Proposed update to Figure 176-2 to more accurately capture "Symbol Demultiplexing" function (in support of comment #420 against D1.3)

Gary Nicholl - Cisco

IEEE 802.3dj, Phoenix, Jan 2025

Current Figure 176-2 (D1.3)

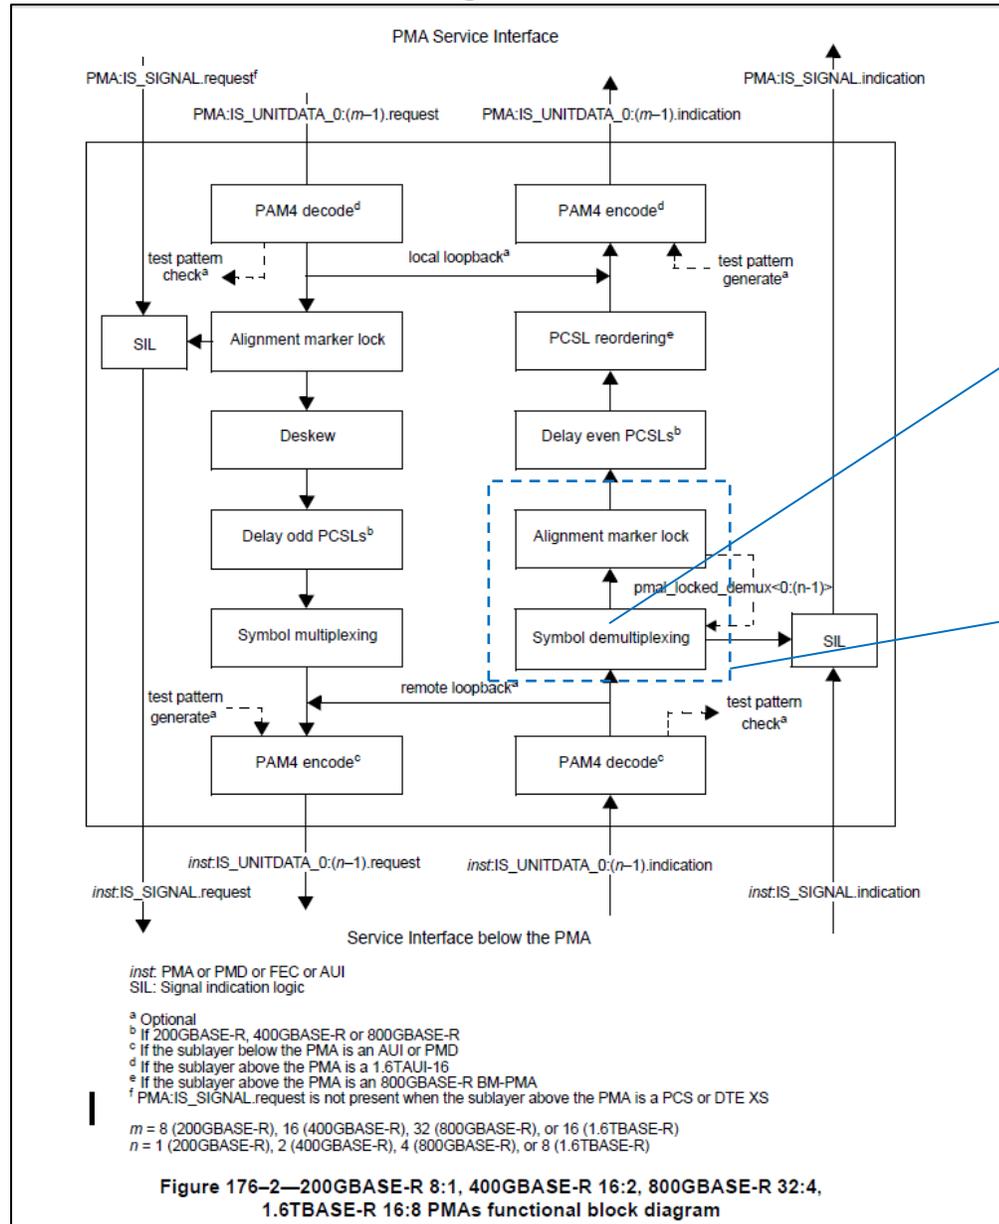
This block by itself does not perform the “symbol demultiplexing” function. This block is really a “blind 20-bit demux and slip” function.

It is the combination of these two blocks and the “pma_locked_demux feedback signal between them, that performs the “symbol demultiplexing” function

Figure 176-2. I find the "symbol demultiplexing" block to be somewhat confusing as this block is essentially a "blind 20-bit demux and slip" function , and only truly represents a symbol demux when the 20-bit demux aligns with the 20-bit symbol-pair boundaries as confirmed by the subsequent "alignment marker lock" function. It is actually the combination of the "blind 20-bit demux and slip" and "alignment marker lock" functions that perform the "symbol demux" .

I think at this level the functional block diagram would be much easier to understand if we were to combine the "symbol demultiplexing" and "Alignment marker lock" functional blocks into a single functional block called "Symbol demultiplexing" . This functional block would internally be comprised of two blocks, "20-bit demux and slip" and "alignment marker lock". These two blocks would be described later in the subclause (perhaps with their own block diagram).

Proposed update to Figure 176-2 (D1.4)

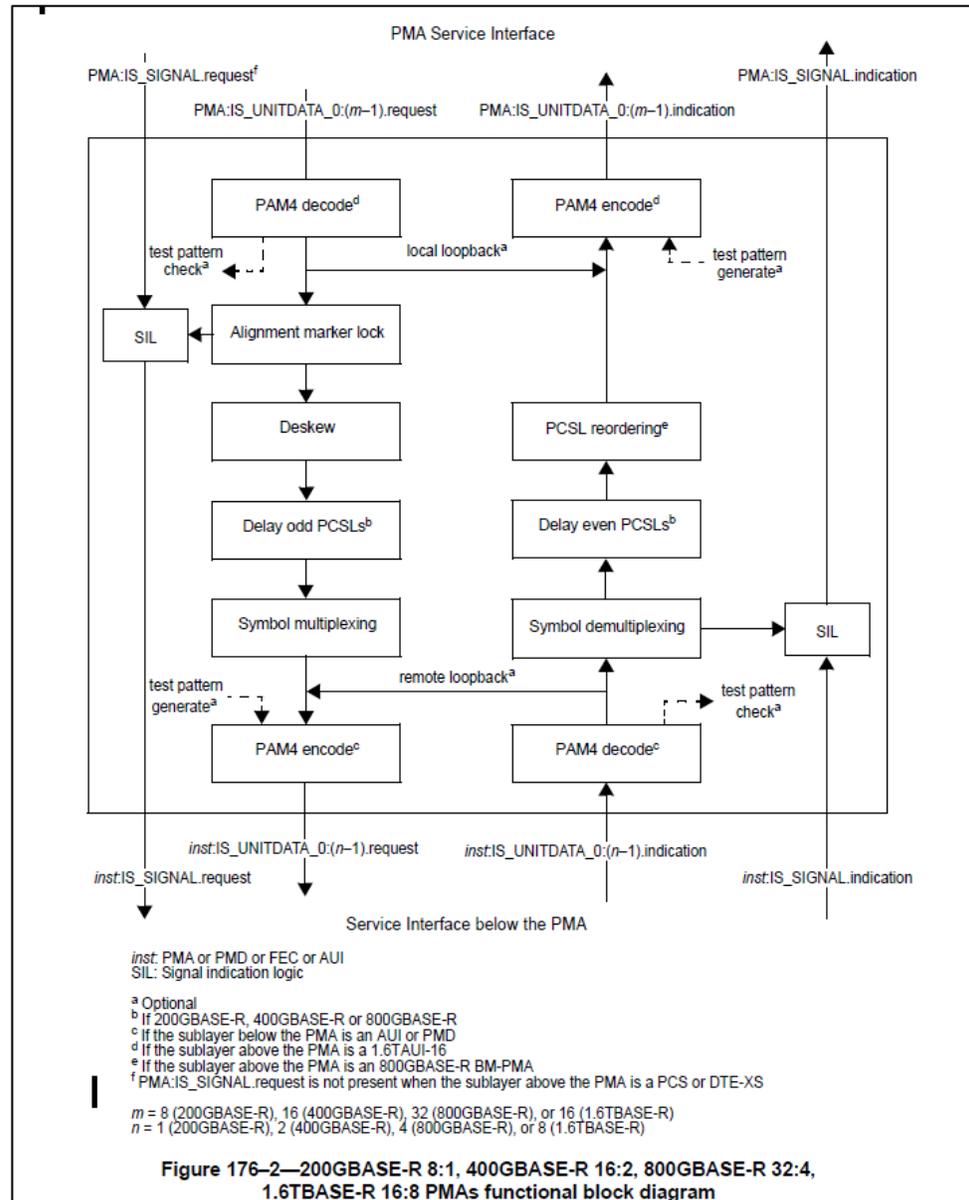
- Comment #420 points out that in Figure 176-2 the "symbol demultiplexing" functional block is somewhat confusing as this block is really a "blind 20-bit demux and slip" function , and only truly represents a symbol demux when the 20-bit demux aligns with the 20-bit symbol-pair boundaries as confirmed by the subsequent "alignment marker lock" functional block.
- It is the combination of that "blind 20-bit demux and slip" and "alignment marker lock" functions that together performs the "symbol demux" .
- This presentation will propose an update to Figure 176-2 to only show a single "symbol demultiplexing" block at this level, and then in the subsequent subclause which defines this function, have a separate diagram showing that the "symbol demultiplexing" block contains two sub blocks; a "blind 20-bit demux and slip" and an "alignment marker lock".
